RE: Preliminary Plan #01-04109  
Burtonsville Shopping Center

We have completed our review of the revised preliminary plan dated June 8, 2005. The Development Review Committee reviewed this plan at its meeting on January 31, 2005. We recommend approval of the plan subject to the following comments:

Re: Montgomery County  
MD 198/ US 29  
Burtonsville Shopping Center  
File No. 1-04109

**SUBJECT:** Burtonsville Shopping Center, Preliminary Plan 1-04109

FIGURE 30

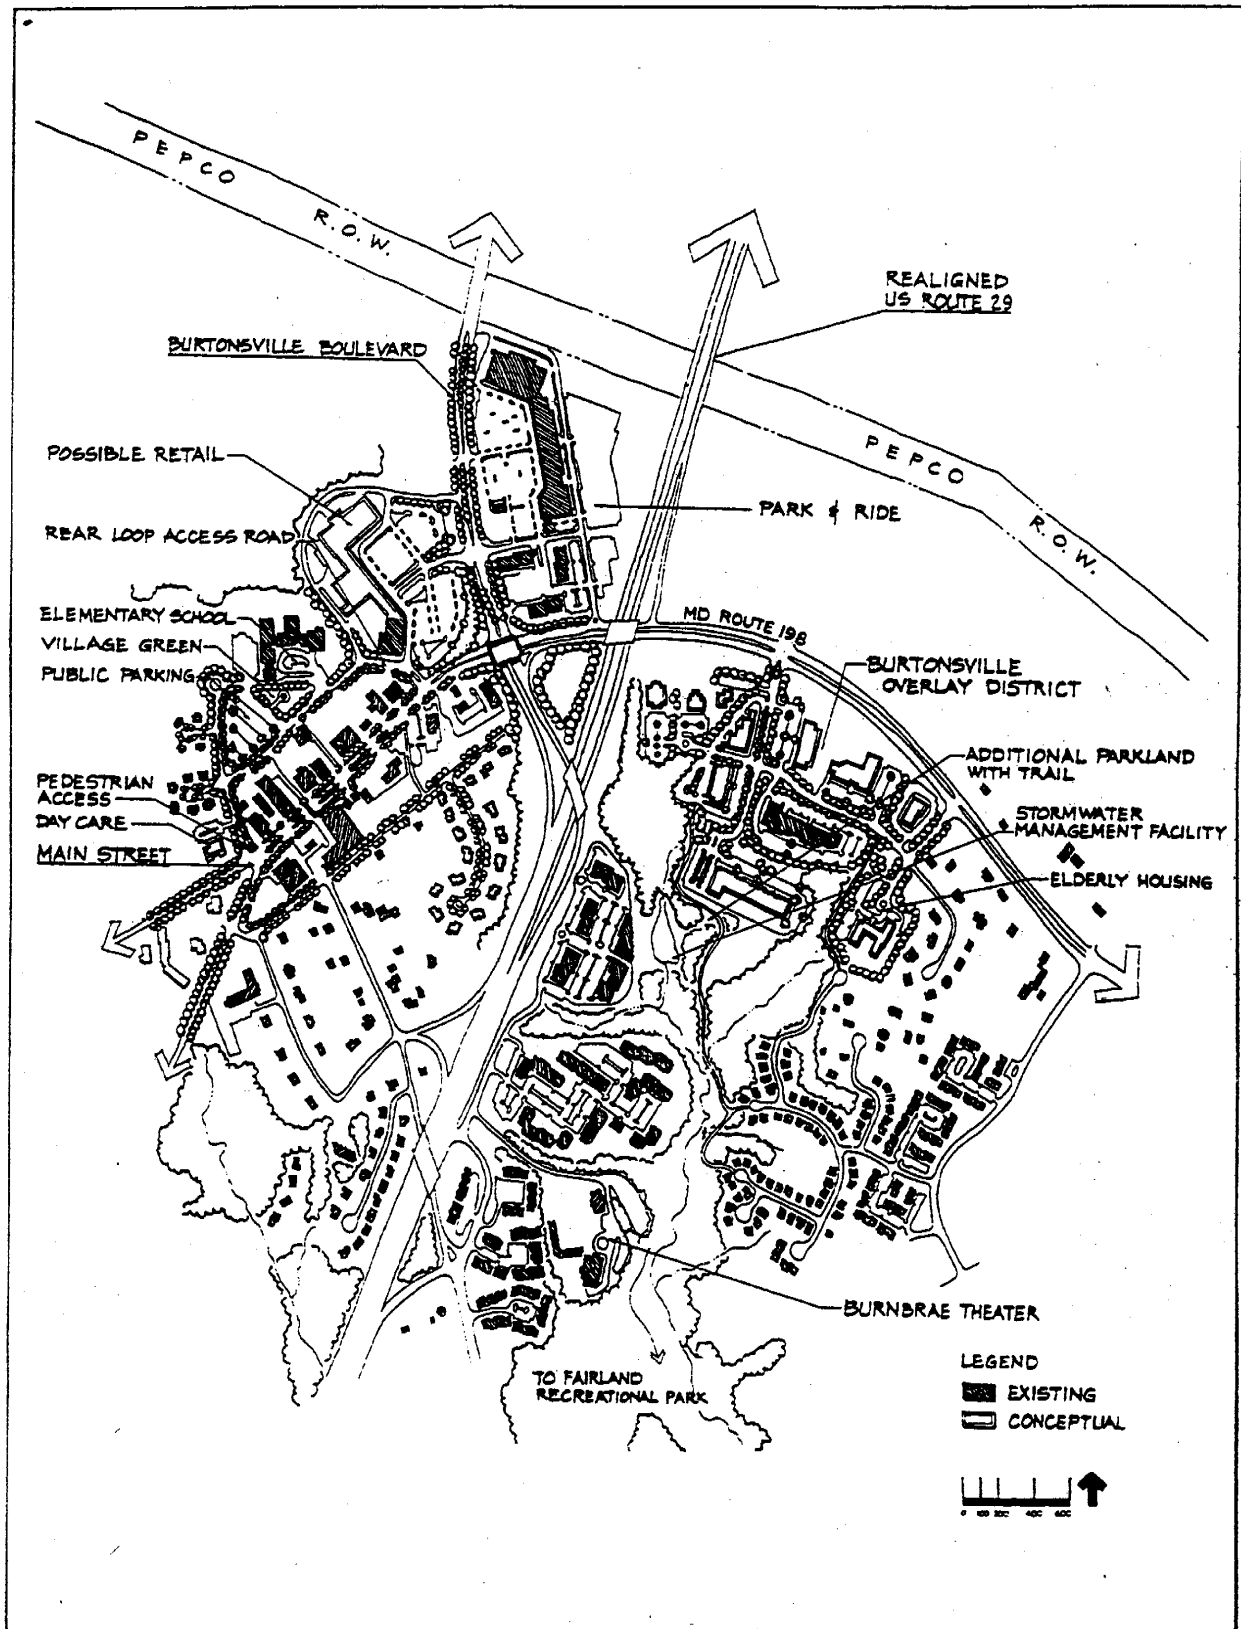
The master plan is ambiguous as to the exact alignment for the loop access road. Page 70 contains illustrative indicating possible alignments for the proposed rear access loop road as well as other features for the Burtonsville Center Concept. The Master Plan of Highways shows a single alignment, B-7, on page 89 that connects to MD 198 only.

This raises the question of reconciling the language in the master plan regarding the location of the loop road exiting US 29 with the proposed circulation on the subject preliminary plan. Access to US 29 will be accomplished through interior drive aisles. The entrance on US 29 is shown as monumental and will connect to the rear access loop road; therefore access to US 29 is achieved.
